NOTICE OF VIOLATION

On June 6, 2024, Energy Safety conducted an inspection of SDG&E's WMP initiatives in the vicinity of the city of Fallbrook, California. The inspection report is enclosed herewith. Energy Safety found the following violation(s):

INSPECTION REPORT

| Electrical Corporation: | San Diego Gas & Electric Company | | | | |
|---|--|--|--|--|--|
| Report Number: | SDGE_YLO_20240606_0812 | | | | |

Item5GImg2: Overall pole

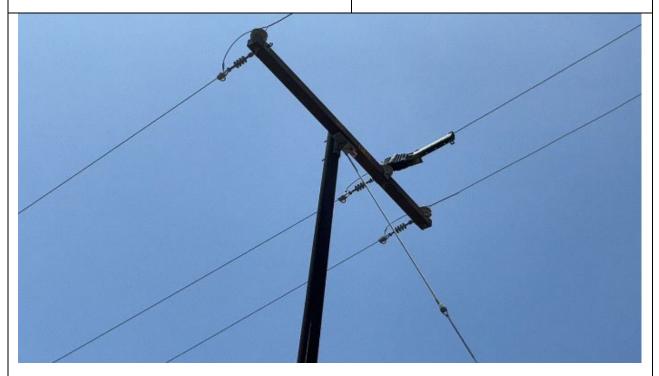
Energy Safety arrived at the pole ID P252330 at 4000-4098 Via San Thomas, Fallbrook, CA, 92028, USA, 33.3178905263497, -117.165591809892, and observed that the avian cover was missing from one side. The inspector's observation is documented in Violation 2 photographs, which are attachments to this report. Photo

numbers Item5GImg2, and Item5IA1Img1 depict that only one side has the avian protection cover and the avian protection cover is missing from the other side.
